**Title:** BOA-19-10300084: A request by Joe Salinas for an appeal of the Director's decision to issue a building permit for a detached accessory with an accessory dwelling unit, located at 225 East Mistletoe. Staff recommends Denial. (Council District 7) (Crystal Gonzales, Development Services Engineer; Debora Gonzalez, Senior Planner (210) 207- 3074, debora.gonzalez@sanantonio.gov, Development Services Department)

**Case Number:** BOA-19-10300084

**Location:** 225 E. Mistletoe Ave

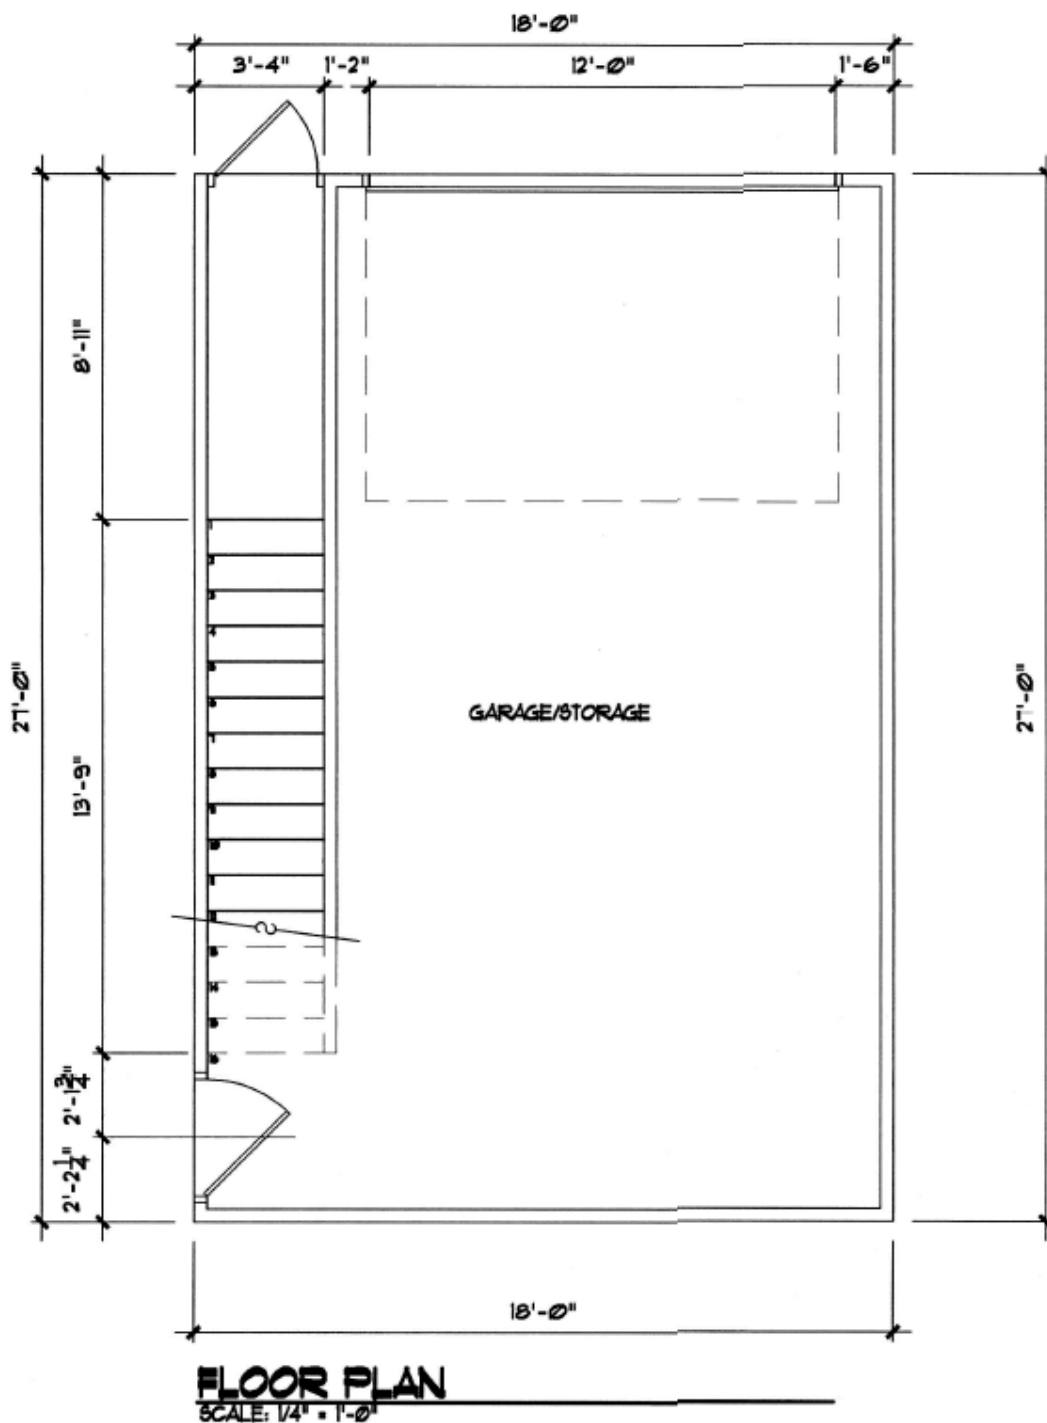
The applicant references this section of code to identify the restrictions on the height, in maximum feet, and the maximum number of stories for a property zoned R-6.

The maximum height of a structure for a property zoned R-6 is 35 feet and 2 ½ stories per Table 310-1.

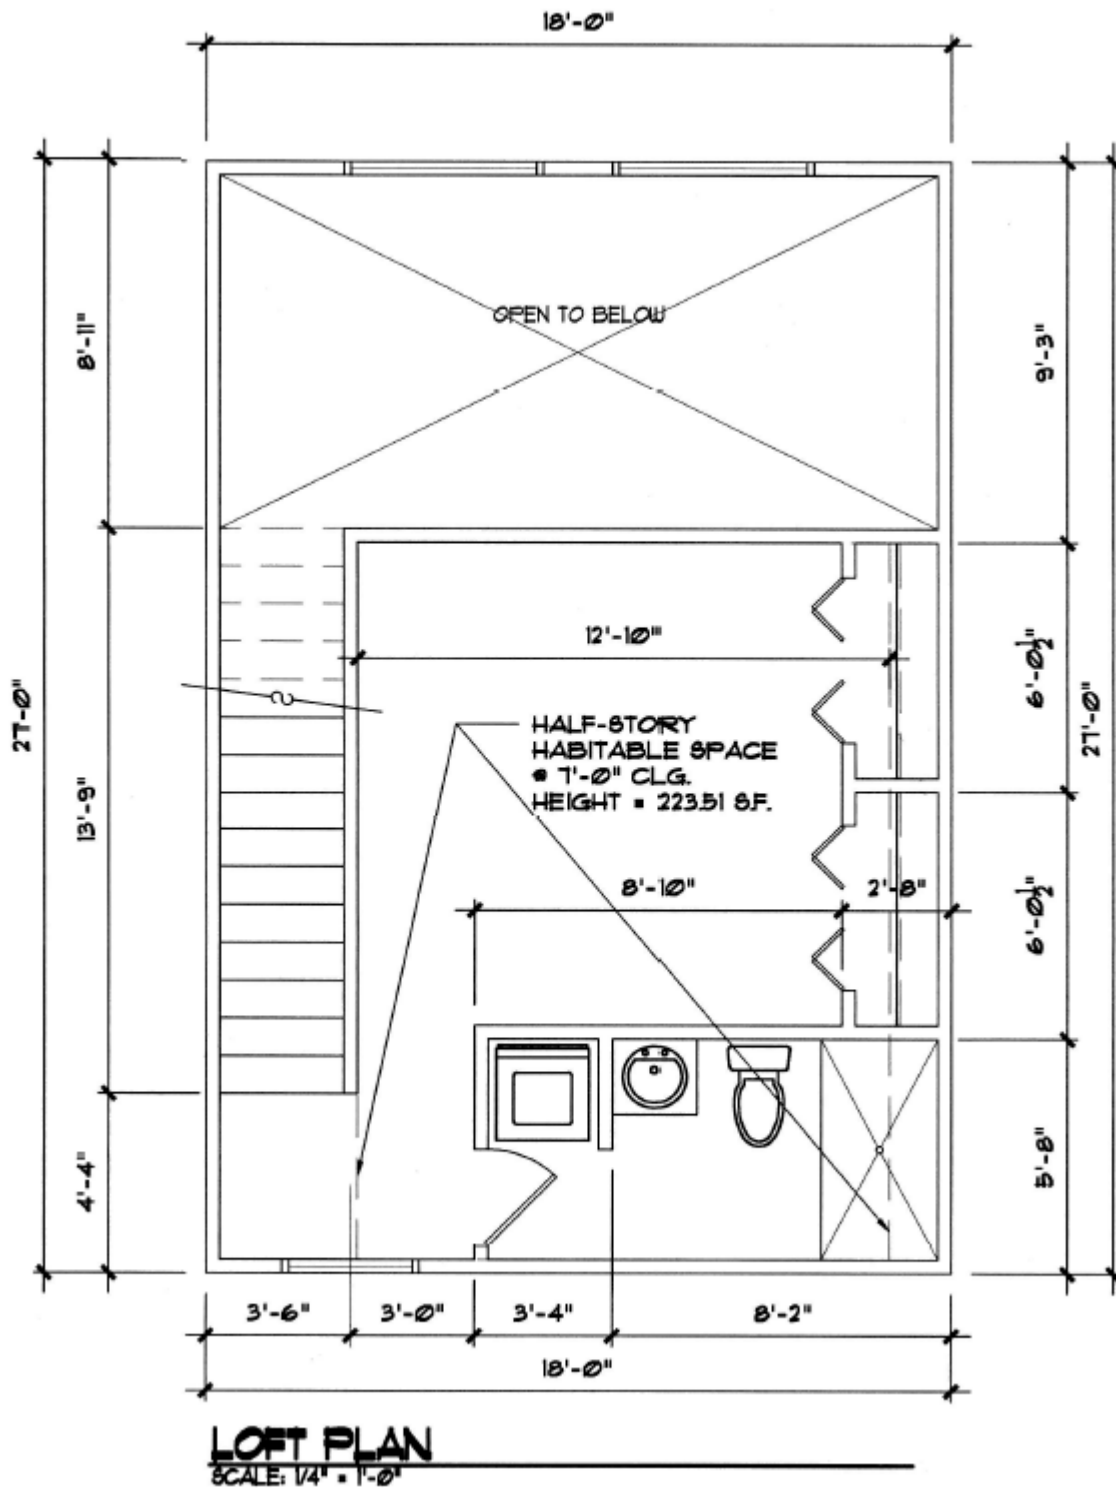
Per the definition of half story, the habitable areas on the uppermost story shall not exceed a floor area derived by multiplying the floor area of the ground floor by fifty (50) percent.

First, the area of the ground floor must be determined from the building plans.

The area of the ground floor is calculated by multiplying 18 feet by 27 feet to obtain a floor area of 486 square feet. Fifty percent of the ground floor area is 243 square feet. The habitable area on the uppermost story cannot exceed a floor area of 243 sf.

The codes clearly recognize that habitable area and floor area are not one in the same. To calculate the habitable area of the uppermost floor, the area of the bathroom, toilet room, closet, hall and storage/utility spaces are excluded from the floor area.

The habitable area of the uppermost floor calculates to be  $486\text{sf} - 166.5\text{sf} - 48.13\text{sf} - 32.2\text{sf} - 65.17\text{sf} = 173.98\text{sf}$  which is well under the allowable floor area of 243sf.
